RE: **Addendum No. 2 to Sealed Bid # I-000319  
Shelby Farms Greenline Extension Project**

SHELBY FARMS GREENLINE  
 EAST EXTENSION

**ADDENDUM #2**

REVISED FIBER OPTIC  
 LAYOUT (REF. DWG. TS101)

**AD-1**

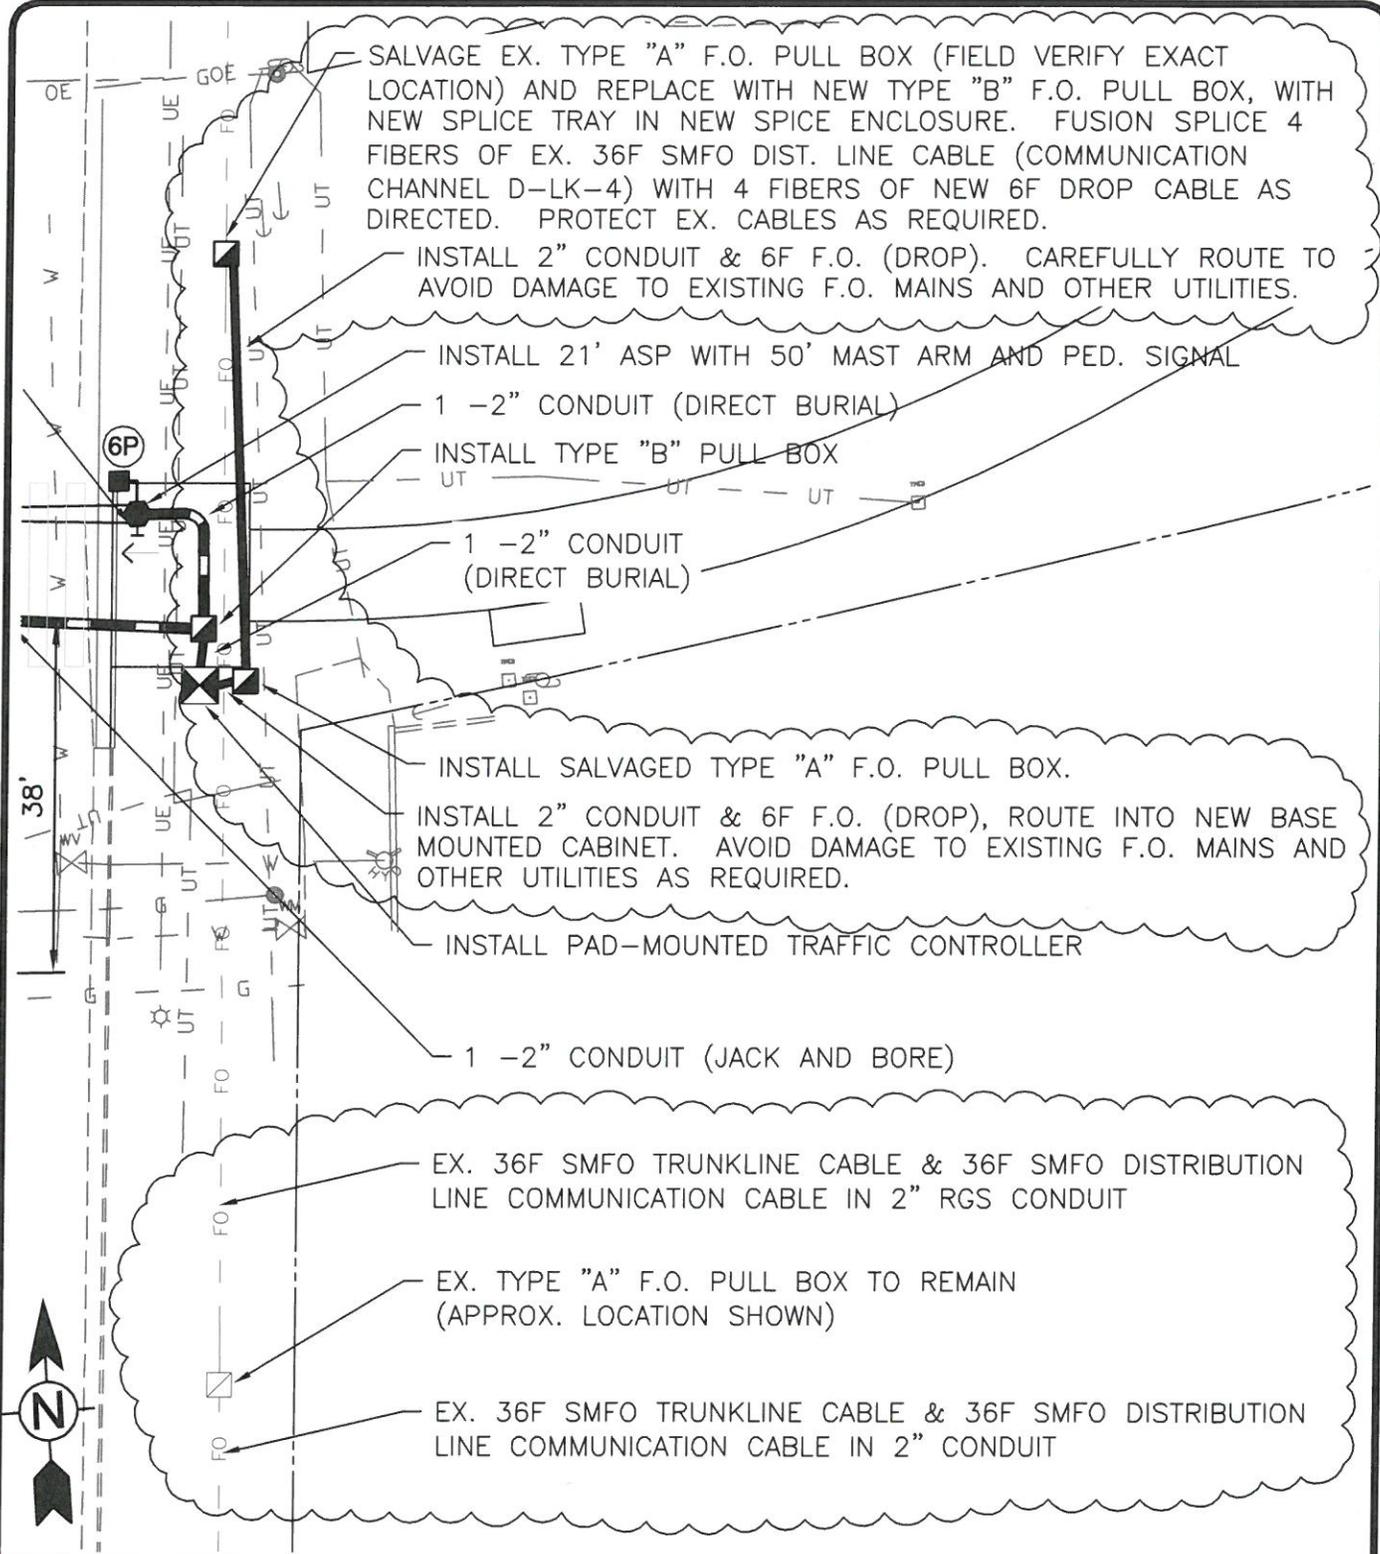
1. **Question:** The Greenline plans call for the City of Memphis Traffic Signal Fiber to be intercepted and a splice installed for the Greenline signal. It does not address where the slack is coming from, or size of fiber to determine number of splices. Can this please be addressed?

11. Refer to Drawings, Sheet TS101. Revise fiber optic layout as shown on attached Drawing AD-1 (8.5”x11”); and add General Notes 24 and 25 to read as follows:

***Answer:*** *The existing fiber optic line on east side of Germantown Parkway includes a 36-fiber SMFO (single-mode fiber optic) trunkline cable and a 36-fiber SMFO distribution line communication cable. Both cables are enclosed by a single 2" conduit. Instead of intercepting the existing mainlines near the new traffic control cabinet, it is now intended that an existing Type "A" F.O. pull box north of the crossing be replaced with a Type "B" F.O. pull box - with new splice tray and splice enclosure, connecting a new 6-fiber drop cable with the existing 36-fiber distribution line, including fusion splicing of 4 fibers. (The existing 36-fiber trunkline cable will remain undisturbed). It is our understanding that there is enough slack available in the existing SMFO distribution cable from other pull boxes, north and south of the new splice enclosure.*

*It is also intended that the existing Type "A" pull box be salvaged and relocated near the new traffic control cabinet. The new 6-fiber drop cable will extend from the splice pull box to the relocated Type "A" pull box, and from said pull box to the new traffic control cabinet. Refer to Revisions section below for further information.*

24. All fiber optic cable used shall meet current City of Memphis material, performance and testing specifications. Contractor shall refer to current version of TDOT standard drawings for fiber optic cable installation.

25. The Contractor is required to have an approved and qualified technician from the fiber optic manufacturer or supplier available to be on site during fiber installation and fiber splicing, as directed by the City of Memphis.
